Wild Meadows Trace Park

Wild Meadows Trace Park is natural area along the Prairie Path. The main issues at this park are curb ramps, truncated domes, slopes, benches with companion seating and an accessible surface. **Please Note:** When a **UD** is indicated, this is a Universal Design (**UD**) recommendation to enhance accessibility. The **UD** recommendation is not required to meet the minimum accessibility standards but it would be encouraged.

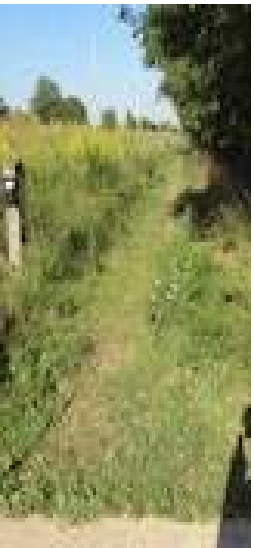
Photo	Barrier	ADAAG/IAC	Solution	Priority	By Whom	Projected Cost	Projected Date	Action Taken
	The curb ramp at the west end of the trail does not provide a proper design.	ADAAG 406	Provide a curb ramp with a running slope no steeper than 8.3% and a cross slope no steeper than 2% and a smooth transition to the sidewalk and street gutter.			\$1,500	2022

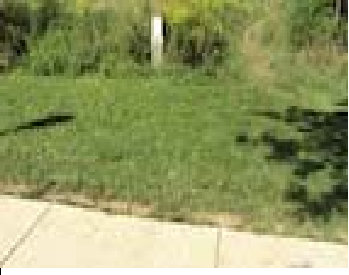
Photo	Barrier	ADAAG/IAC	Solution	Priority	By Whom	Projected Cost	Projected Date	Action Taken
	No accessible route to Shooting Star Trail brochure holder for 11'.	ADAAG 403.3	Relocate the brochure holder to an accessible route or provide a new accessible route with a running slope no steeper than 5% and a cross slope no steeper than 2% and a minimum clear width of 36".			\$375	2022	
	The Shooting Stair Trail is a natural trail that does not provide an accessible material.	<u>Proposed</u> Outdoor Areas Standards ADAAG 1017	Trail Recommendation: In this is a formal trail, when upgrading the trail surface, provide a surface material such as a 3/4" minus limestone with a 50% mix of dust that is firm and stable with a slope no steeper than 2% for a cross slope and no steeper than 5% for a running slope. Provide this surface at the benches, trash cans and signs along the way.			\$2,000	2022

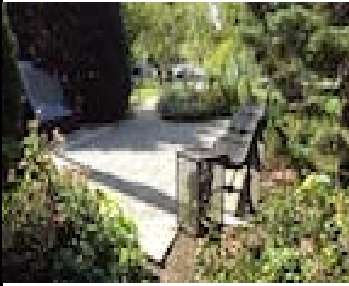
Photo	Barrier	ADAAG/IAC	Solution	Priority	By Whom	Projected Cost	Projected Date	Action Taken
	The trash can is located in the grass.	<u>Proposed</u> Outdoor Developed Areas Guidelines 1011	Trash Can Recommendation: Locate trash cans on an accessible route as part of your regular policy. For a forward approach provide a trash can within 24" and a minimum clear ground space of 36" by 48" or for a side approach provide a trash can within 24" and a minimum clear ground space of 30" by 60".			\$50	2019	
	The walkway at the curb ramp has a cross slope too steep at 2.6% to 3.3% for 11'.	ADAAG 403.3	Attempt a "mud jacking" technique or remove and regrade section to provide a cross slope no greater than 2%.			\$1,500	Work with City on replacing

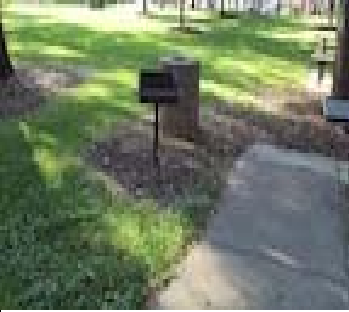
Photo	Barrier	ADAAG/IAC	Solution	Priority	By Whom	Projected Cost	Projected Date	Action Taken
	The trash can on Spring Road is located 28" off the sidewalk.	Proposed Outdoor Developed Areas Guidelines 1011	Trash Can Recommendation: Locate trash cans on an accessible route as part of your regular policy. For a forward approach provide a trash can within 24" and a minimum clear ground space of 36" by 48" or for a side approach provide a trash can within 24" and a minimum clear ground space of 30" by 60".			\$50	2019	
	No access to brochure holder on Spring Road for 21'.	ADAAG 403.3	Relocate the brochure holder to an accessible route or provide a new accessible route with a running slope no steeper than 5% and a cross slope no steeper than 2% and a minimum clear width of 36".			\$700	2019	
	The sidewalk to the gazebo area has an abrupt transition of 1".	ADAAG 303	Grind down or replace section of sidewalk to provide a smooth transition.			\$275	2019

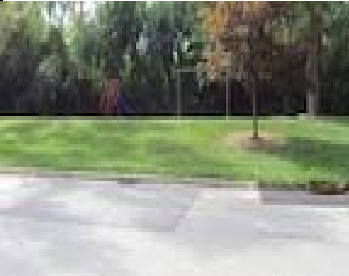
Photo	Barrier	ADAAG/IAC	Solution	Priority	By Whom	Projected Cost	Projected Date	Action Taken
	<p>No accessible surface is provided at the grill for 6'.</p>	<p>Proposed Outdoor Developed Areas Guidelines ADAAG 1011.5</p>	<p>Grill Recommendation: Follow Outdoor Developed Area Report that states 20% of grills, but at least two, be of accessible design, and connected to an accessible route. The accessible grill should provide a cooking surface a minimum of 15" to 34" maximum AFF above the ground surface, a clear floor space and controls that are within a maximum reach range of 48" AFF. And a 48" by 48" space centered on the usable sides of the grill is required.</p>			\$50	2019

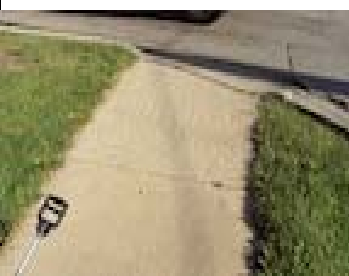
Photo	Barrier	ADAAG/IAC	Solution	Priority	By Whom	Projected Cost	Projected Date	Action Taken
	The dog waste bags are mounted too far from the sidewalk at 5'.	ADAAG 308	Provide a reach range no higher than 48" AFF for a forward reach over an obstruction no deeper than 20" or a side reach of 48" AFF over an object no deeper than 10".			\$50	2012	Moved closer to sidewalk
	The trash can is located 10' off the accessible route.	<u>Proposed</u> Outdoor Developed Areas Guidelines 1011	Trash Can Recommendation: Locate trash cans on an accessible route as part of your regular policy. For a forward approach provide a trash can within 24" and a minimum clear ground space of 36" by 48" or for a side approach provide a trash can within 24" and a minimum clear ground space of 30" by 60".			\$50	2012	Moved closer to sidewalk

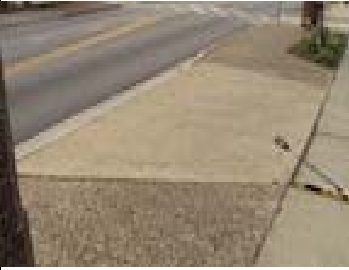
Photo	Barrier	ADAAG/IAC	Solution	Priority	By Whom	Projected Cost	Projected Date	Action Taken
Public Sidewalks and Their Issues at Wild Meadow Trace								
	The west sidewalk northwest curb ramp at Berkley Avenue does not provide truncated domes.	ADAAG 705	Provide truncated domes that go the width of the sidewalk and 24" deep where it meets the road. Provide a color that contrast with the walkway surface. Truncated dome tiles are typically a more durable solution.					Replaced by the City 2014
	The east sidewalk northeast side has a branch that protrudes at 72" AFF.	ADAAG 307	Trim the branch to provide an 80" minimum clear head space and back to the edge of the walkway.			\$50	2012	Branches trimmed 11/2012
	The east sidewalk in the middle has a cross slope too steep at 2.6% to 3.3% for 6'.	ADAAG 403.3	Attempt a "mud jacking" technique or remove and regrade section to provide a cross slope no greater than 2%.			\$360		Work with City's replacement schedule

The south curb ramp has a gutter slope of 21.5%	ADAAG 406.2	Remove and replace the gutter adjoining a curb ramp to have a slope no steeper than 5% on the street side and 8.3% or less on the ramp side .			\$360		Work with City's replacement schedule
